Model: Adonis-P		Date: 31-Oct-99	No.: RG035001
Subject: Service Manual Corrections		Prepared by: K. Takagi	
From: Technical Service Dept., GTS Division			
Classification:	<input type="checkbox"/> Troubleshooting <input type="checkbox"/> Part information <input type="checkbox"/> Action required		
	<input type="checkbox"/> Mechanical <input type="checkbox"/> Electrical <input checked="" type="checkbox"/> Service manual revision		
	<input type="checkbox"/> Paper path <input type="checkbox"/> Transmit/receive <input type="checkbox"/> Retrofit information		
	<input type="checkbox"/> Other (      )

Please make the following corrections in your Adonis-P service manual.

Model: Adonis-P		Date: 31-Jan-00	No.: RG035002
Subject: Service Manual Correction		Prepared by: K. Takagi	
From: Technical Service Dept., GTS Division			
Classification:	<input type="checkbox"/> Troubleshooting <input type="checkbox"/> Part information <input type="checkbox"/> Action required <input type="checkbox"/> Mechanical <input type="checkbox"/> Electrical <input checked="" type="checkbox"/> Service manual revision <input type="checkbox"/> Paper path <input type="checkbox"/> Transmit/receive <input type="checkbox"/

### • EtherTalk (AppleTalk) Network (Page 3-11)

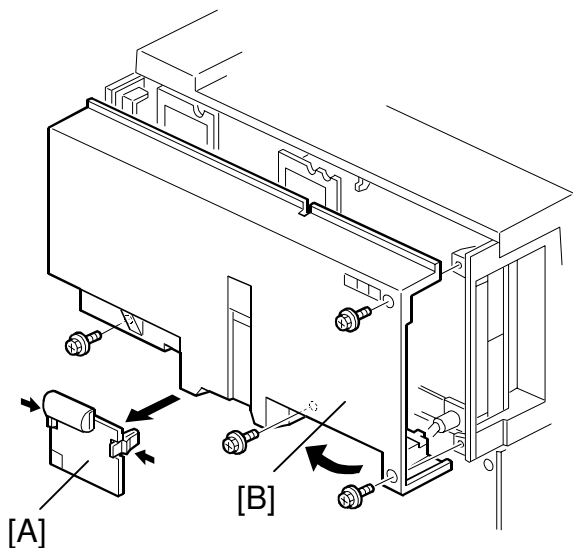
#### **Incorrect:**

Parameter	Default Setting	How to change the parameter
AppleTalk Enable/Disable	Enabled	MAP, web browser and telnet.
Printer Name	Plug&Play name ( <u>SP5-907</u> )	See Note.
Zone Name	Default zone	See Note.

Parameter	Default Setting	How to change the parameter
AppleTalk Enable/Disable	Enabled	MAP, web browser and telnet.
Printer Name	Plug&Play name ( <u>SP2-21</u> )	See Note.
Zone Name	Default zone	See Note.

- **Upper Cover (Page 6-48)**

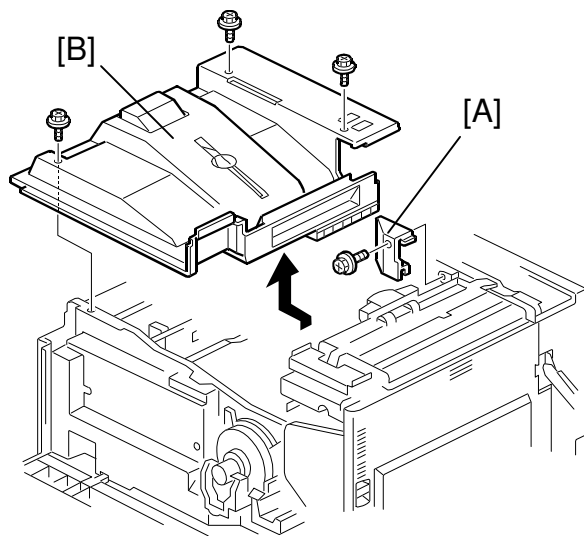
The wrong illustration is attached for the upper cover removal.

- **Engine SP: Memory All Clear (Page 4-12)**

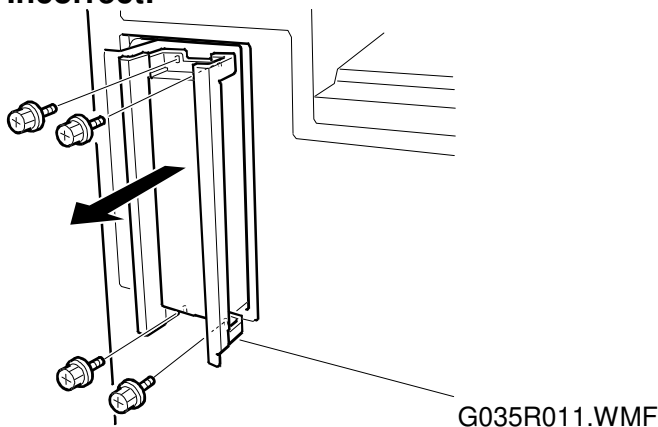
**Incorrect:**

Resets all correction data for process control and all software counters.

**Correct:**

Resets the correction data for process control and software counters except for the following items.

- Electrical total counter value
- PM counter value
- Machine serial number
- P&P brand name and production name setting

- **Printer Control Board and NIB (Page 6-50)**

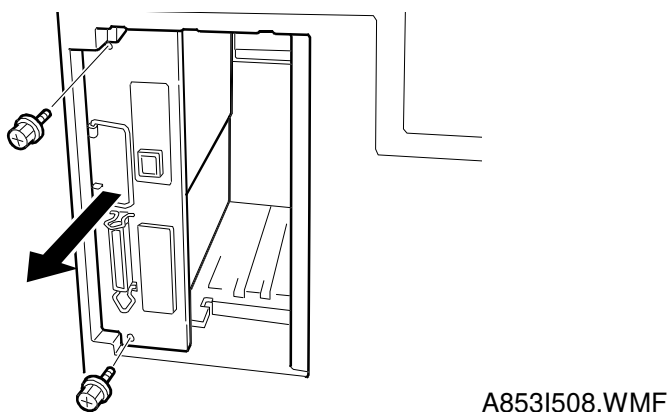
The wrong illustration was attached.

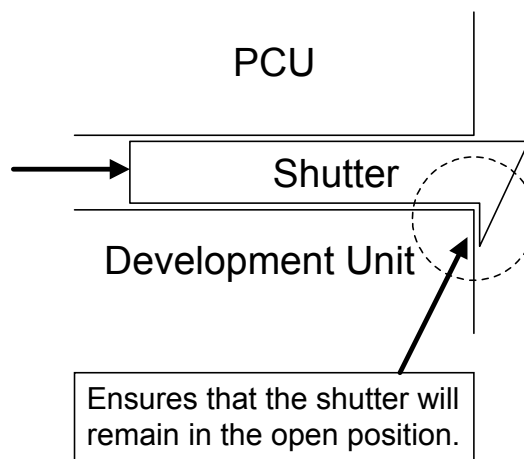
The toner supply shutter (parts catalog pg.27, index #28) returns to the closed position when the PCU unit (PCU and development unit) is put in the machine.

Normally, the shutter is not in the closed position when the machine is shipped out. However, if the technician removes the PCU unit from the machine and attempts to separate the PCU from the development unit, the shutter may return to the closed position.

1. The length of the pawl edge of the shutter was increased by 2.5 mm to prevent the shutter from returning to the closed position.
2. The tension spring (parts catalog pg.27, #27) included in the user maintenance kit was deleted.

If you should experience any future occurrences, remove the PCU unit from the machine, check the position of the shutter and return it to the open position if necessary (see the illustration below). After this, carefully place the unit back in the machine.

### • PHOTOCONDUCTOR UNIT (Page 2-16)

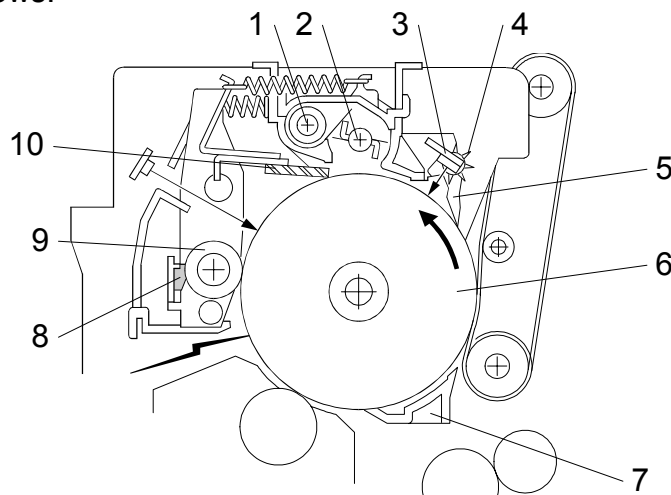
There were incorrect callout numbers for the overview illustration. Correct the illustration as follows:

### • PAPER REGISTRATION (Page 2-44)

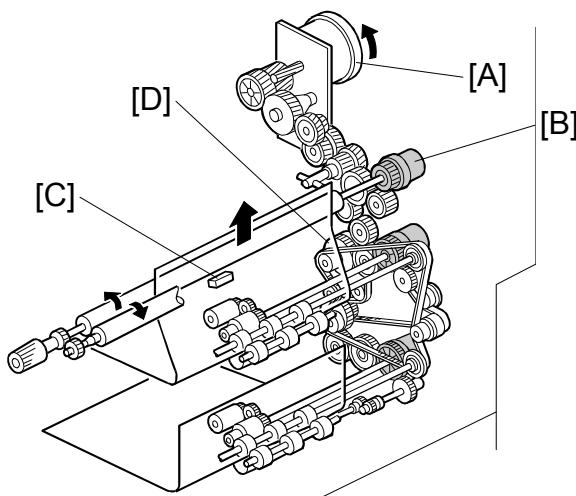
There was a missing callout and an incorrect callout in the illustration. Correct the illustration as follows:

- **PHOTOCONDUCTOR UNIT (PCU) AND DEVELOPMENT UNIT (Page 6-6)**

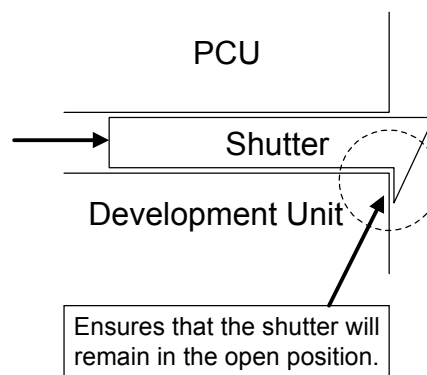
The following illustration and description should be added:

**NOTE:** Make sure that the toner supply shutter [C] is at the open position before reinstalling the unit.

### Copy Flash ROM (Sp1-3)

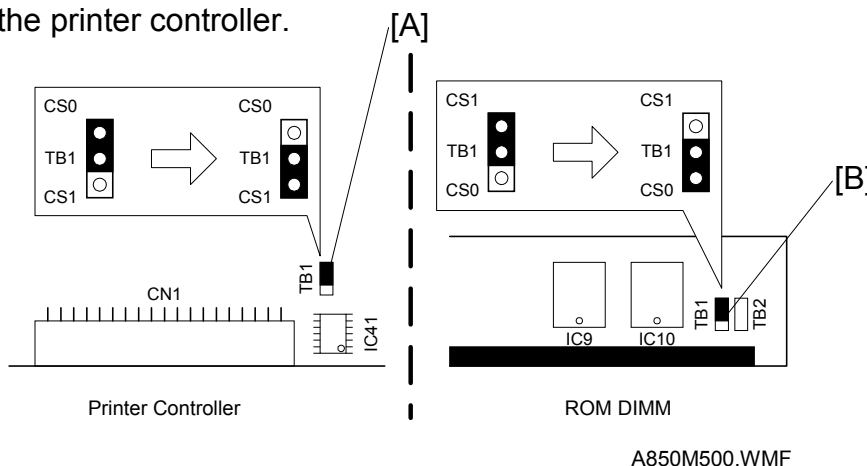
The following procedures should be added.

2. Change the position of the TB1 jumper [A] on the controller from CS0 to CS1.
  3. Change the position of the TB1 jumper [B] on the ROM DIMM that contains the controller firmware from CS1 to CS0.
  4. Install the ROM DIMM on the controller.
- CAUTION:** Make sure to install the correct ROM DIMM in the PS SIMM connector.
